TB 1-1520-240-20-154

### MANDATORY MAINTENANCE ON TRANSIENT AND AVOID BANDS ON THE CRUISE GUIDE INDICATOR ON ALL CH-47D AIRCRAFT

Headquarters, Department of the Army, Washington, D. C.  
3 May 2004

FIGURE 1

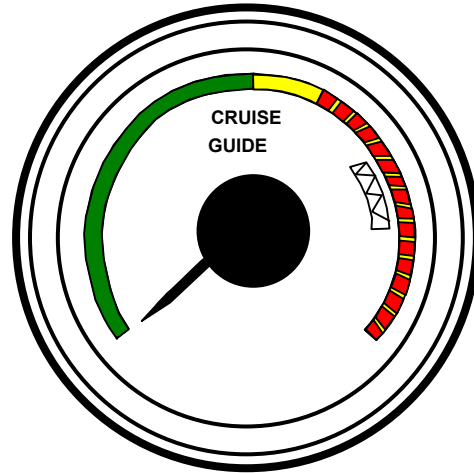
- c. Re-marking of the CH-47D CGI, part number 152BUA34-2 or 114VS805-3 shall be performed within 10 flight hours/14 days per the instructions below.

- (1) Utilizing Figure 1, cut out the “re-marked” Cruise Guide Indicator template.
- (2) Cut out the red/yellow striped (avoid) band from the Figure 1 “re-marked” CGI template.

- (3) Center the “re-marked” template on the aircraft CGI (P/N 152BUA34-2 or 114VS805-3).
- (4) Tape the outside edges of the “re-marked” template to the CGI.

- (5) Apply red instrument marking tape to the CGI display glass at the location where the red/yellow striped band was removed from the Figure 1 template. If instrument tape is unavailable then a piece of red tape placed on the glass at the beginning of the new red/yellow striped region denoted by the “re-marked” template is sufficient.

Measuring with a protractor placed in the center of the gauge, the red band of the new avoid region begins at 63 degrees above horizontal. The red band arc length of the new avoid region is 1 7/16". The new yellow band arc is 5/16" long.

The yellow band on the re-marked CGI represents 100% to 120% rotor control/drive system design load. The red (avoid) band on the re-marked CGI begins at 120%.

(a) Change Figures 2-14-1 and 5-2-1 to reflect the same length red/yellow striped arc as in figure 1 "Remarkd" gage. Measuring with a protractor placed in the center of the gauge, the red band of the new avoid region begins at 63 degrees above horizontal. The red band arc length of the new avoid region is 1 7/16". The new yellow band arc is 5/16" long.

....Insure that the diameter of the diagram matches the  
 ....diameter of the gauge. The inner diameter of the bands is 1.4".  
 ....Measuring with a protractor placed in the center of the  
 ....gauge, the red band of the new avoid region begins at 63  
 ....degrees above horizontal. The Red Band Arc length of the  
 ....new avoid region is 1 7/16". The new Yellow Band Arc is  
 ....5/16" long.
